## Product Change Notice (PCN)

**Subject:** Change in Marking Format on Select Humidity Sensor

**Affected Product List:** HS3001, HS3002, HS3003, HS3004

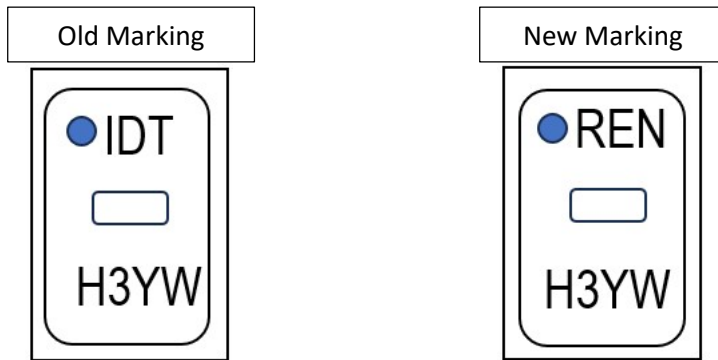
Renesas is changing the marking format by replacing “IDT” with “REN” as shown in the below diagram. No change to form, fit, function, reliability and quality of the product.
